CITY OF ALBUQUERQUE

RE: 8609 Mesa Rain Rd NW
Grading and Drainage Plan
Engineer's Stamp Date: 07/18/24
Hydrology File: H09D017A3

Based upon the information provided in your submittal received 07/16/2024, the Grading & Drainage Plan is approved for Grading Permit (earthwork can get started for the earth pad on the house and retaining walls).

| ENGINEER'S SEAL DAVID SOULE NEW MEXICO REGISTERED PROFESSIONAL ENGINEER 14522 7/18/24 DAVID SOULE P.E. #14522 | LOT 52 WATERSHED SUB. 8609 MESA RAIN GRADING AND DRAINAGE PLAN  P.O. BOX 53924 ALBUQUERQUE, NM 87199 (505) 321-9099 | DRAWN BY DEM |

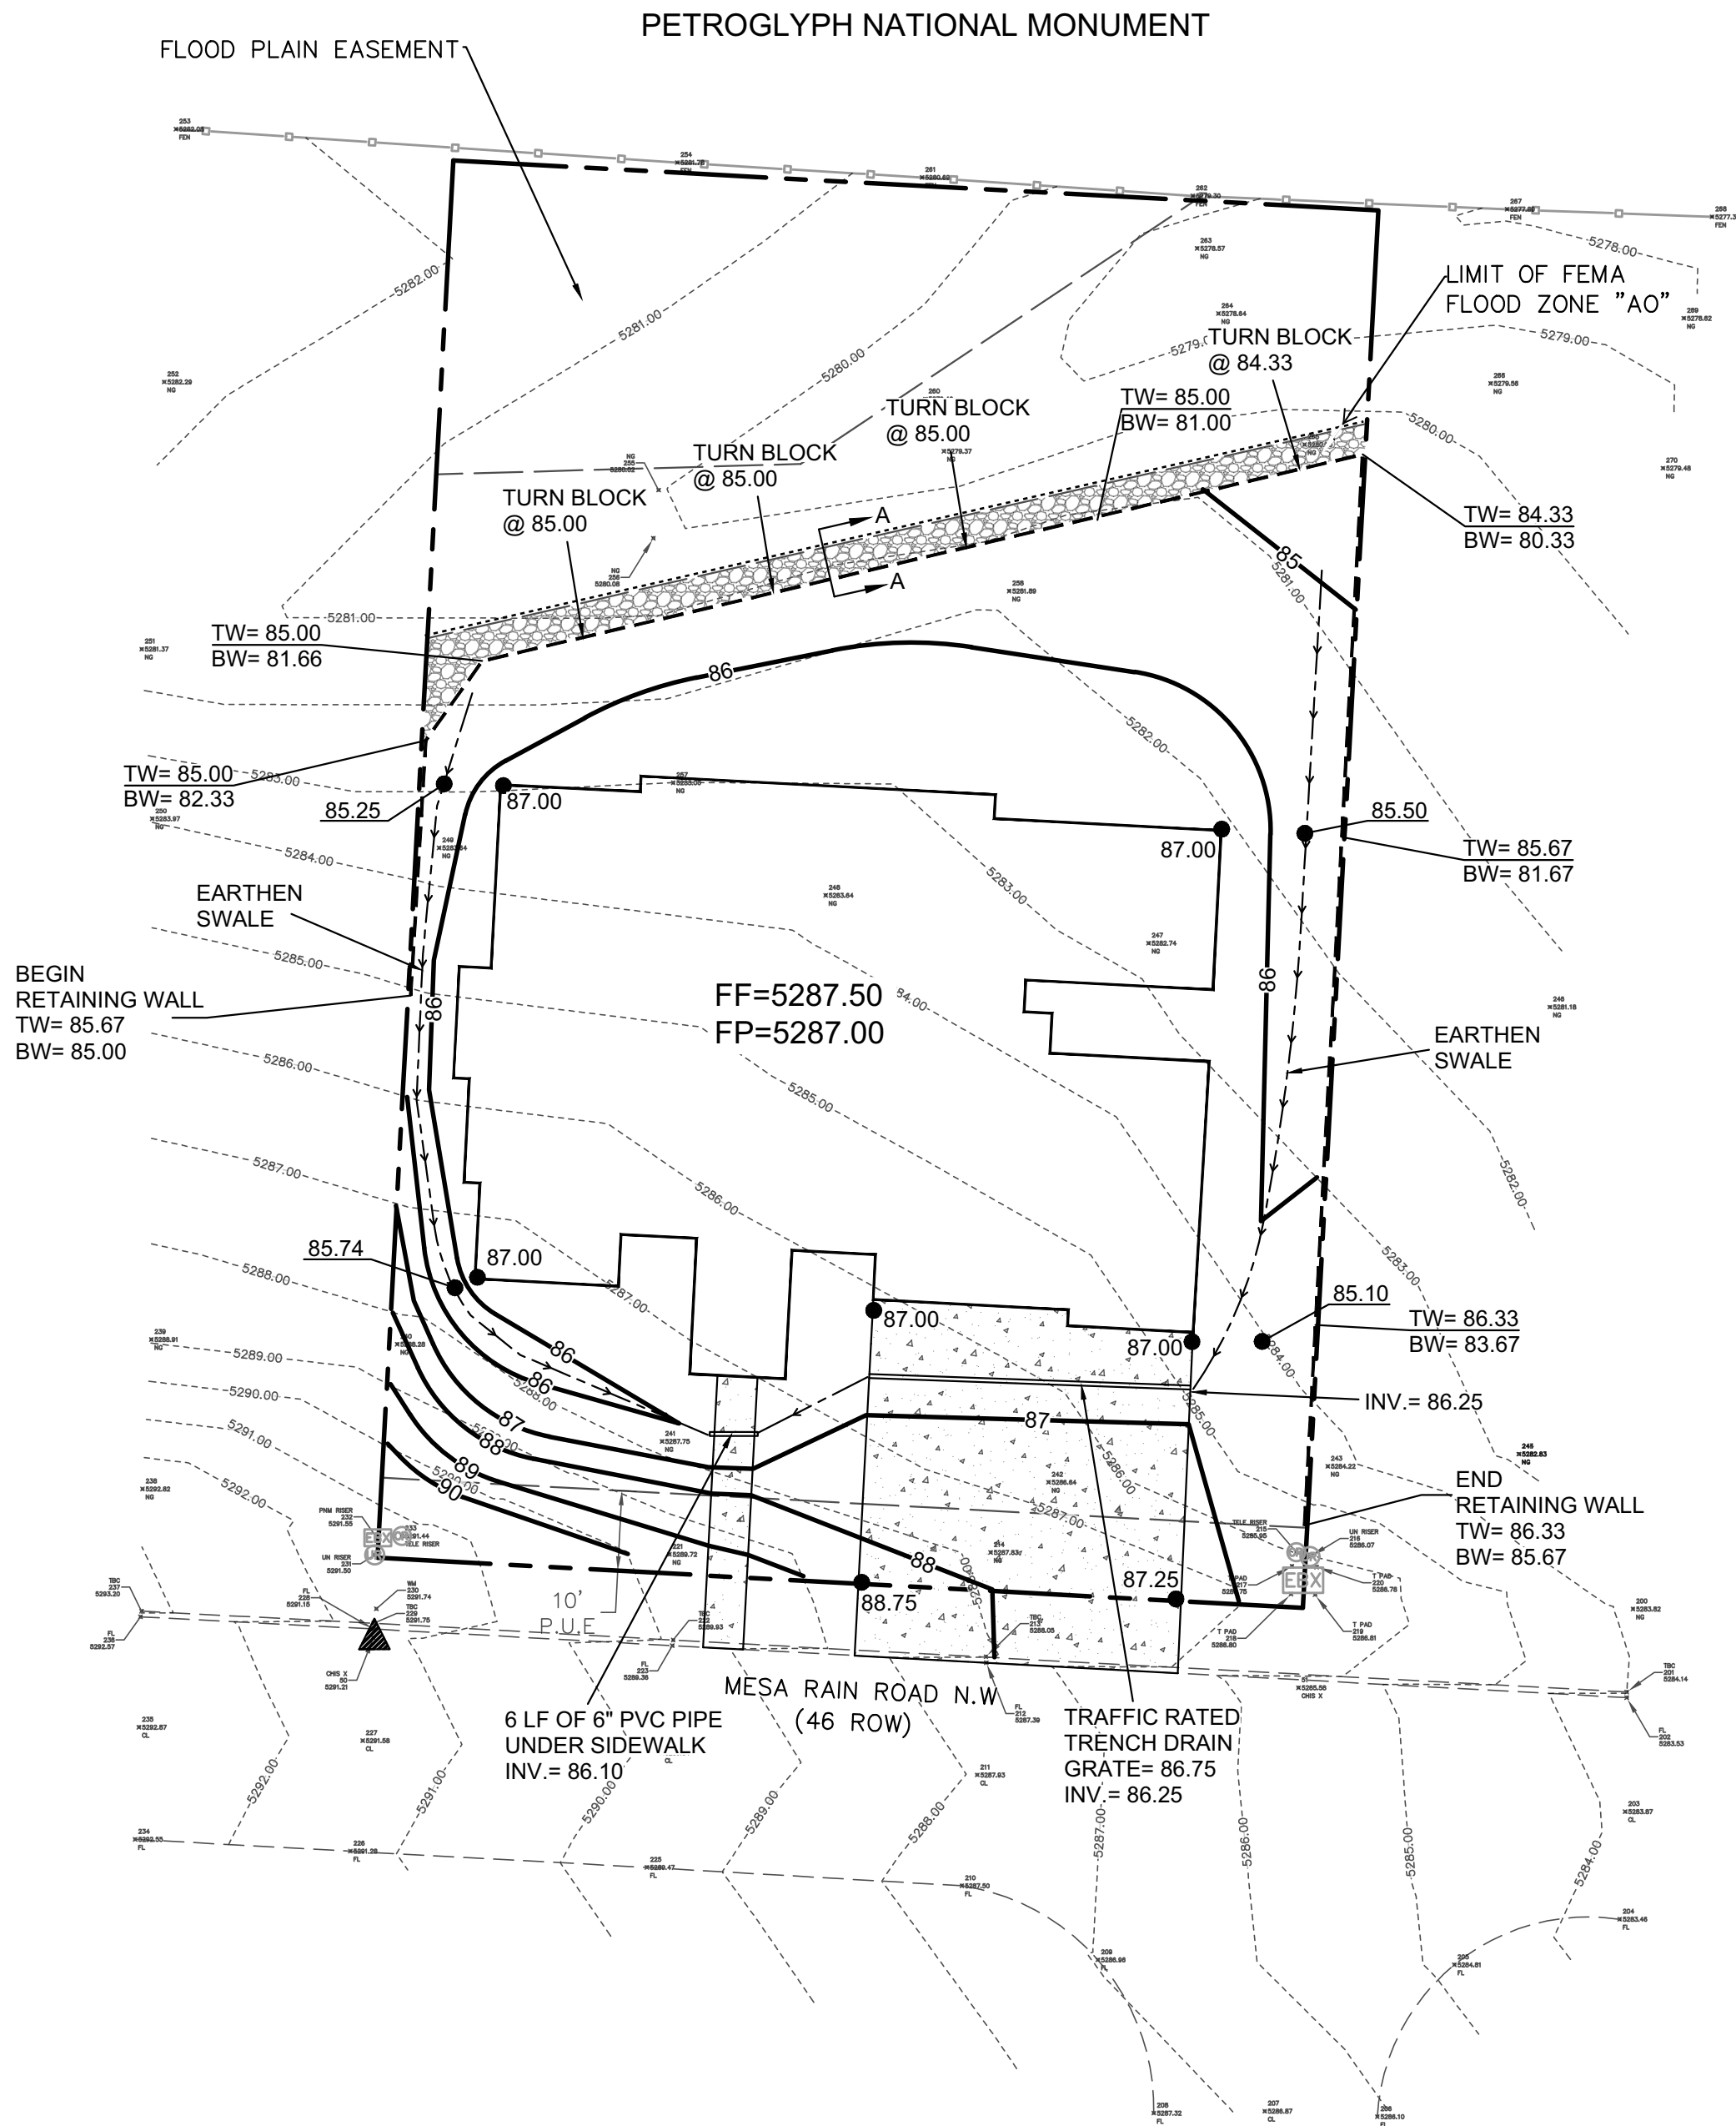
1. Once the grading is complete, a pad certification (meaning that the earthwork and retaining walls are complete) will be required. Please include a site photo with the submittal. Also, at the time of pad certification approval, Hydrology will concurrently approve the Grading & Drainage Plan for Building Permit.
